AMENDMENTS TO THE DRAWINGS

Atty. Ref. No.: 7287-000012

Title: FLOWCHART-BASED CONTROL SYSTEM INCLUDING
AUTOMATIC DOWNTIME AND CYCLE TIME ANALYSIS

Figure 1

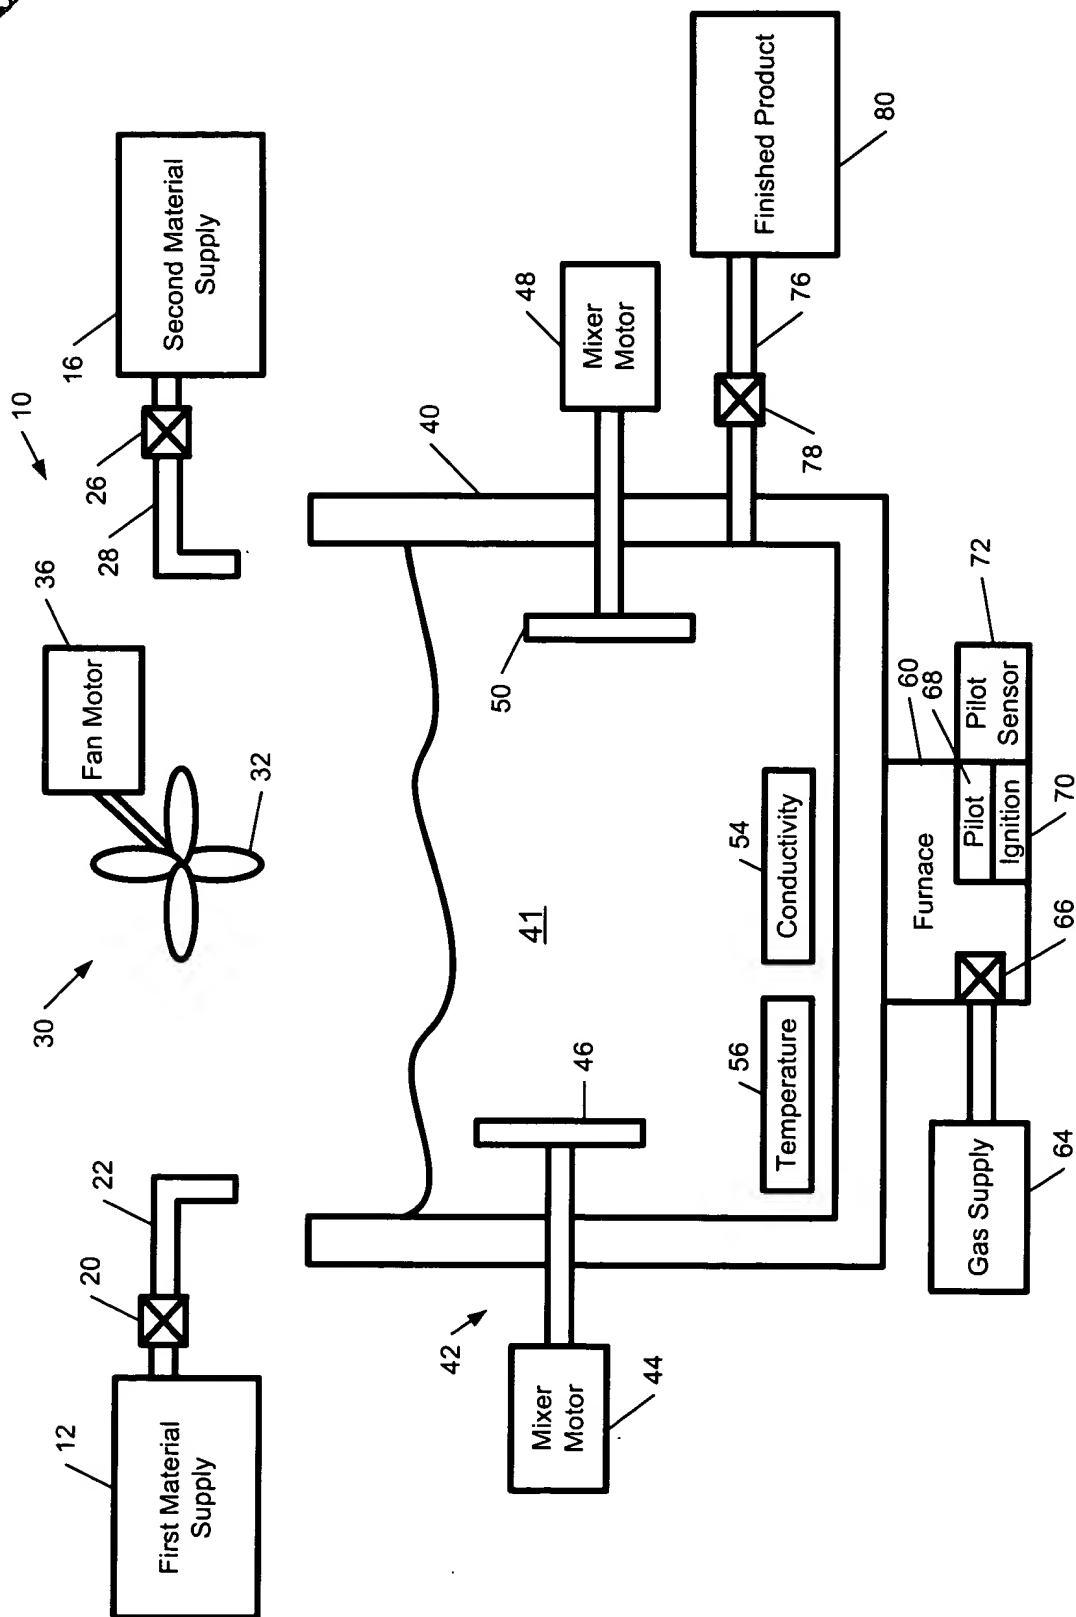
In Figure 1, the arrow 46 has been deleted. In Figure 2, the reference number 150 has been changed to 176. In Figure 3A, the reference number 142 has been changed to 60. In Figure 4, the reference number 224, associated with "Remove" box, has been changed to 226. In Figure 4, the reference numbers 235-1 has been changed to 235-2 and 235-3.
